Title: Cavalon Oil Thermostat Assembly Upgrade		Compliance Category: A – MANDATORY B – RECOMMENDED C – OPTIONAL
AG-SB-2020-02-B-ENr2		
Applicability		
Aircraft type & model: AutoGyro Cavalon	Affected Serial number(s): All Cavalon fitted with the Rotax 915iS engine up to V00473 but excluding V00398, V00443 & V00450	
The maintenance manual to be referenced is this stated or subsequent issue.		As per AutoGyro website
This form is the response from AutoGyro GmbH either against a problem found in the product in service requiring a containment or rectification action, or as service information for aircraft modification incorporation. For help, contact AutoGyro on +49(0)5121 88056-00, or email airworthiness@auto-gyro.com .

Reason and overview of the Service Bulletin (cause of problem if known)

(Pic. 1)

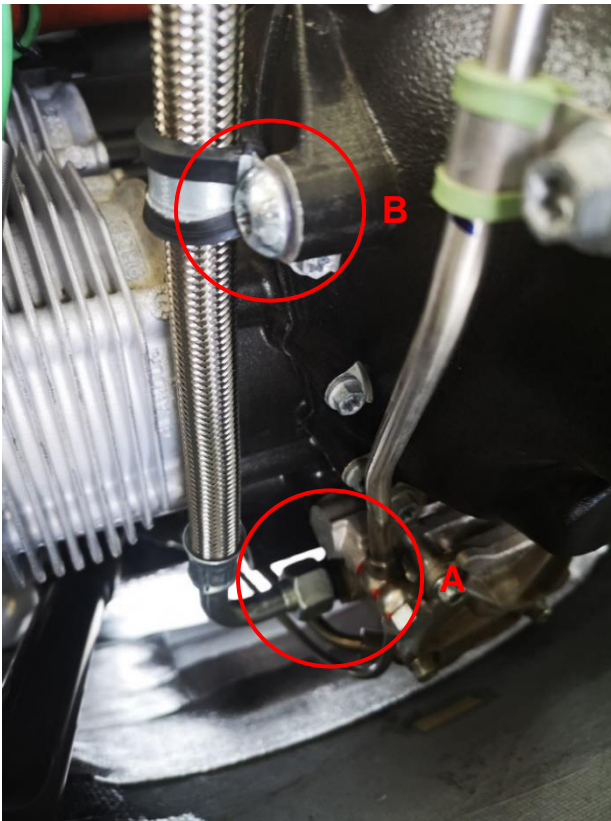
4. Confirm the size of the adaptor at the oil pump (Pic. 1 item A). If the thread size is anything other than 22mm then it must be replaced with adapter **45583**. This should be assembled in the pump housing using Loctite 243 blue. If the thread is 22mm then no further action is required.

6. Return the oil in the system to the tank by turning the propeller until a gurgling sound is heard.
7. Place a container under the oil pump at the rear of the engine, and disconnect the oil hose (Pic. 1, item A). Allow any oil to drain and remove the P-clamp (Pic. 1, item B).

(Pic. 2)

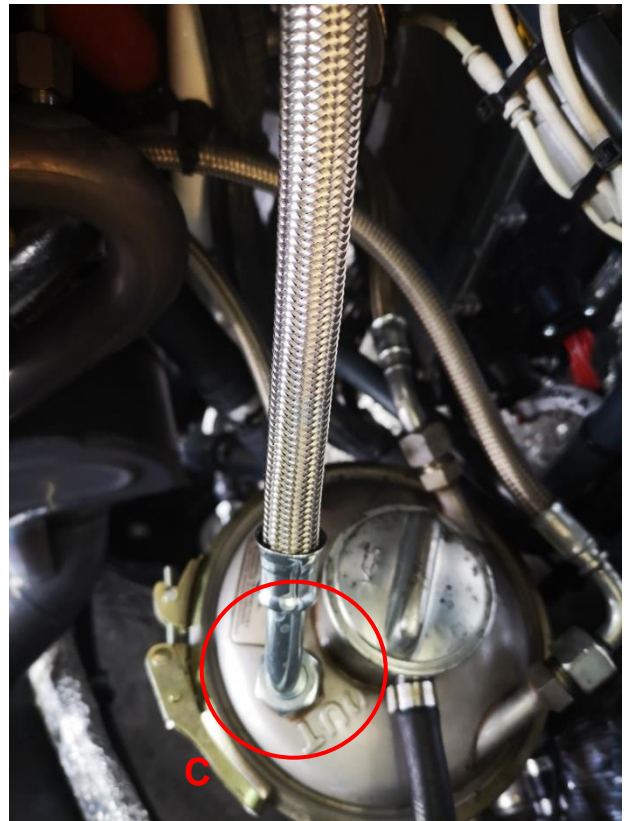
5. Confirm the size of the connection at the oil tank (Pic. 2). If the thread size is 18mm then adapter **45534** is required. This should be assembled in the oil tank using Loctite 638 green. If the thread is 22mm then no further action is required.

8. Disconnect the return hose from the right side oil cooler at the oil tank connection (Pic 2, item C)
9. Place a container under the oil cooler hose connections and disconnect the 4 hoses from the oil coolers (Pic 3. Items D, E, F & G). NOTE: Ensure to counter the adapters when dis-assembling and assembling the hoses on the coolers.
Note: The thermostat and hoses are now supplied as separate items.

This revision (r1) introduces an amendment to paragraph 5 of the Accomplishment Instructions. “Confirm the size of the adapter at the oil cooler (Pic. 2).” Has been changed to read “Confirm the size of the connection at the oil tank (Pic. 2).”

(Pic. 3)

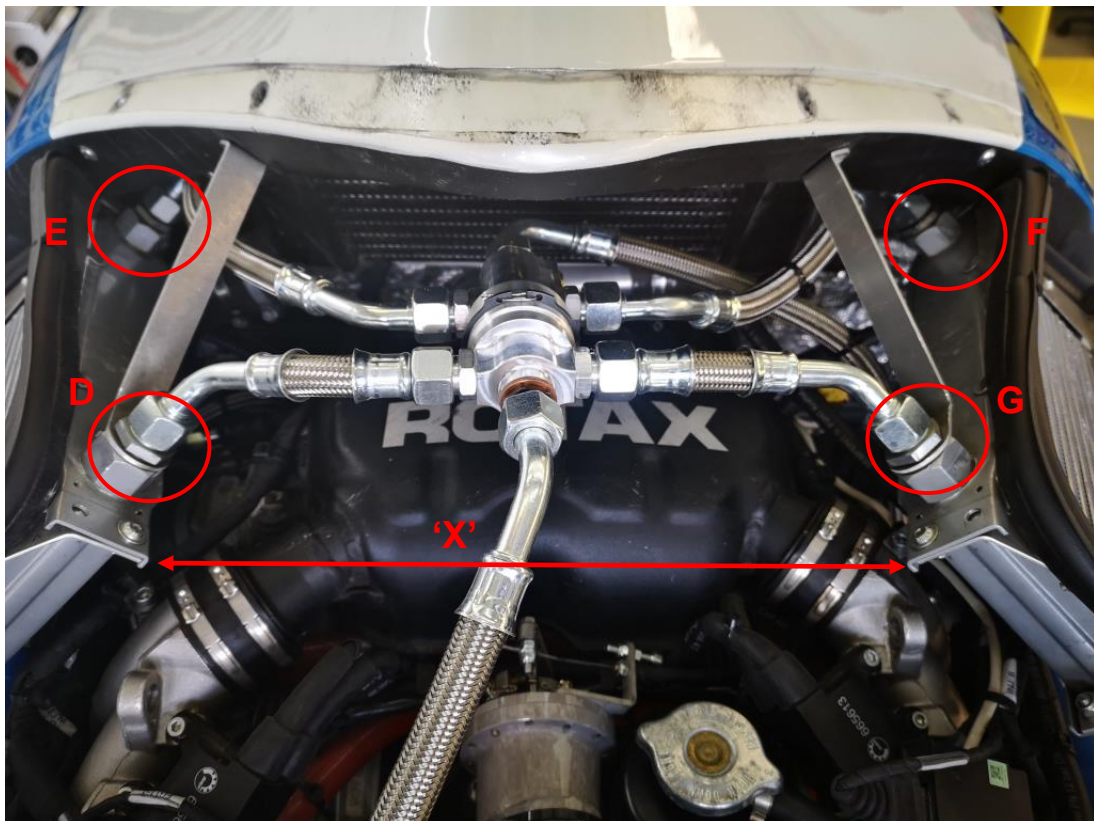
3. Measure the distance between the oil cooler corners as shown in Pic. 3 dimension 'X' to determine which hose set is required. If dimension 'X' is 280mm then oil hose set **47896** is required, if dimension 'X' is 335mm then oil hose set **47817** is required.

(Pic. 4)

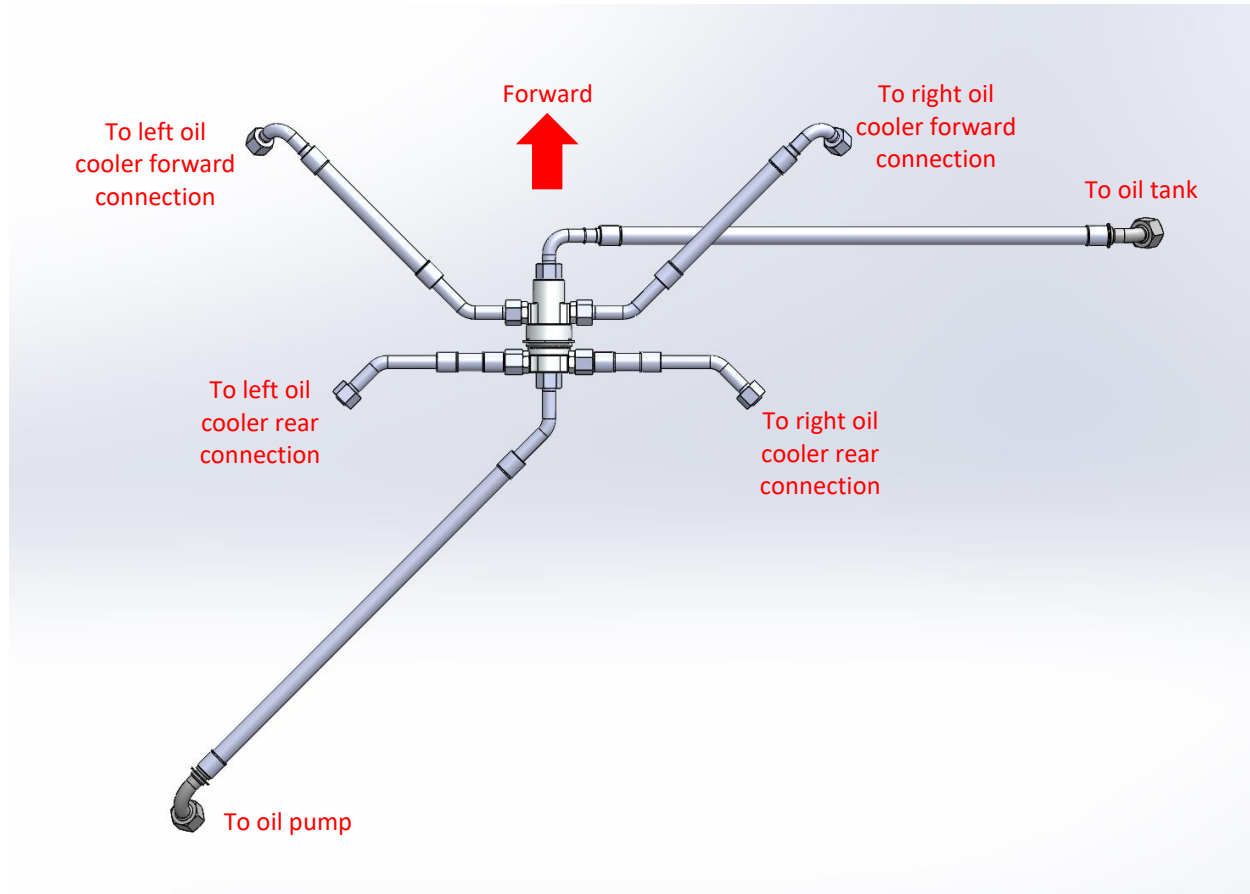
10. Assemble the new hoses (47896 or 47817) to the new thermostat (47748) loosely. Ensure that the items are assembled in the correct orientation as shown in Pic. 4.
